E8802A-01C

S E R V I C E N O T E

E8802A PNA Series RF Network Analyzers

Serial Numbers: 00000000 thru 46999999

Figure 1

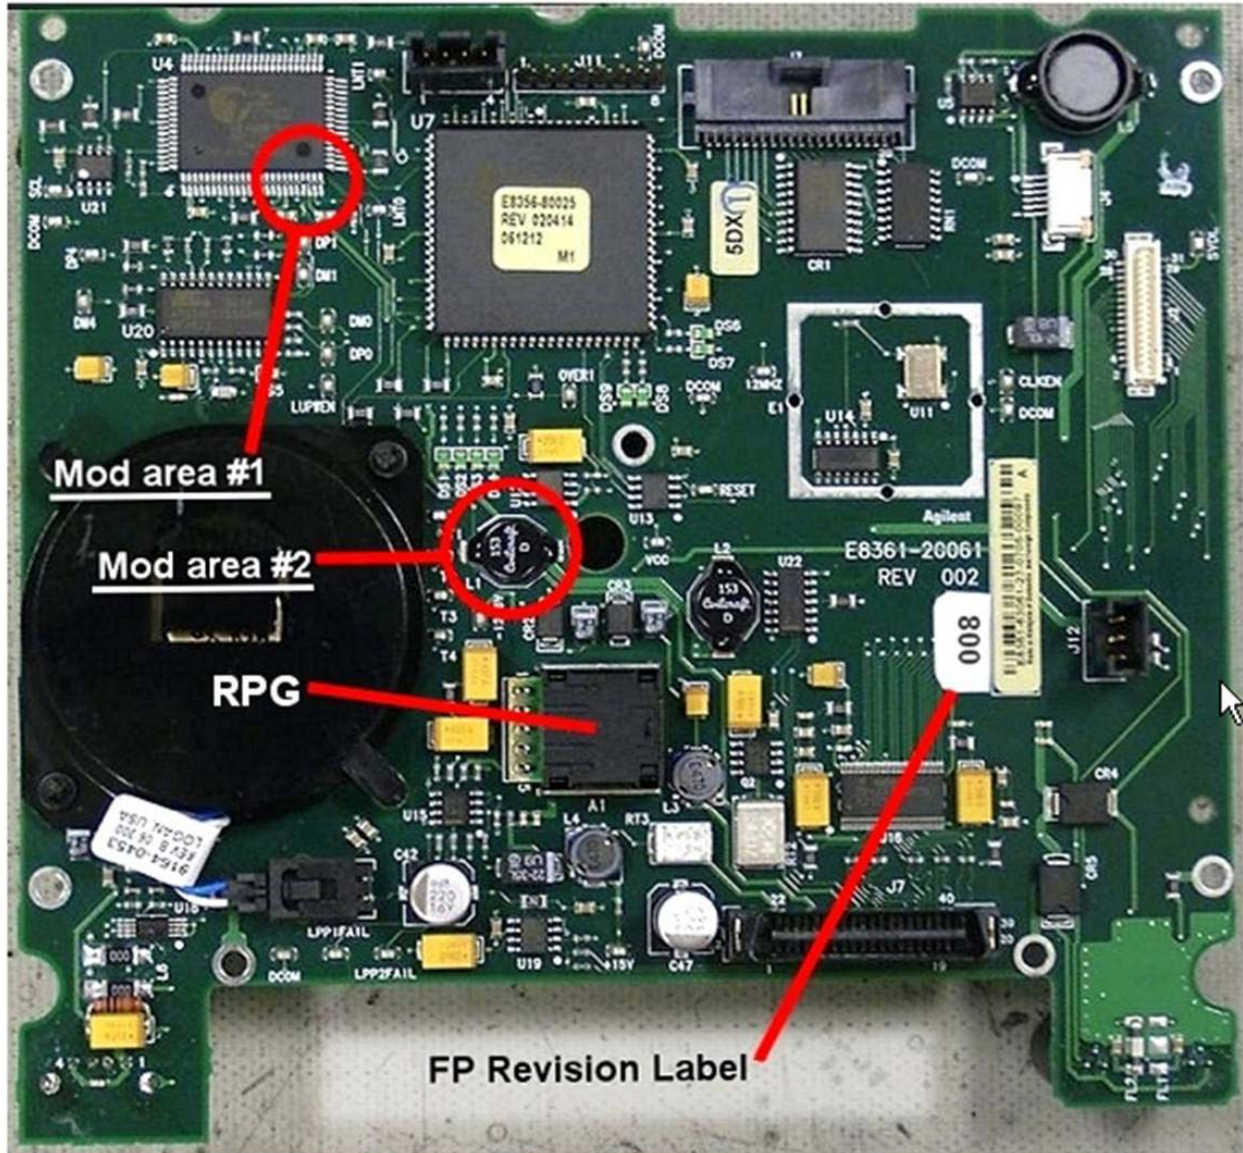
Refer to Figure 1 for the two modification areas to be addressed. Note that while this picture happens to show the FPI board completely removed from the front frame assembly, this is not necessary to perform the required modifications.

- Modification #1 consists of shorting two pins of U4 together with a small amount of solder.
- Modification #2 consist of removing L1.

Figure 2

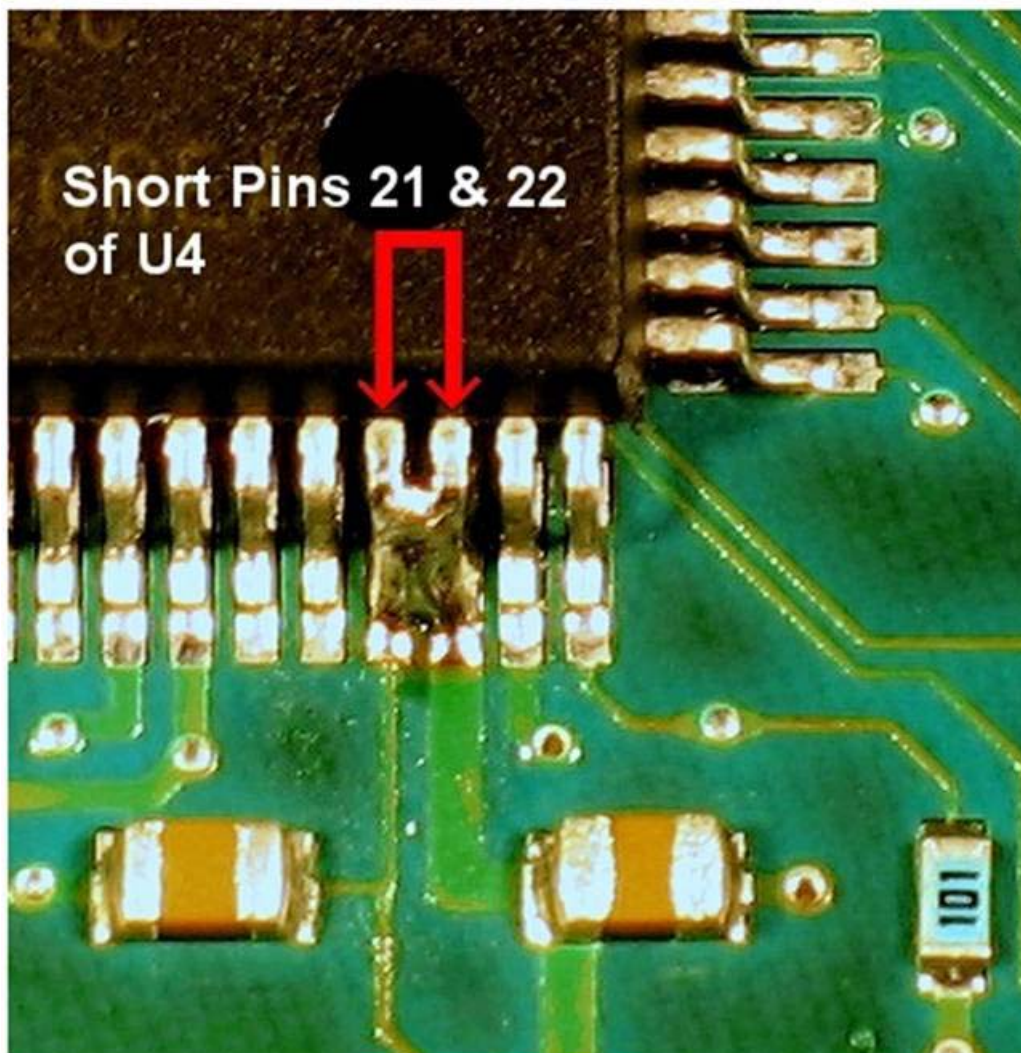
Carefully solder pins 21 and 22 together on U4. Refer to Figure 2 for the exact location. Use care so that no other pins are shorted. Use of a very fine tip soldering iron is recommended and a large work-task magnifying glass is very helpful.

Unsolder and completely remove the black surface mount inductor L1 from the front panel assembly board. This is no longer needed and can be discarded.
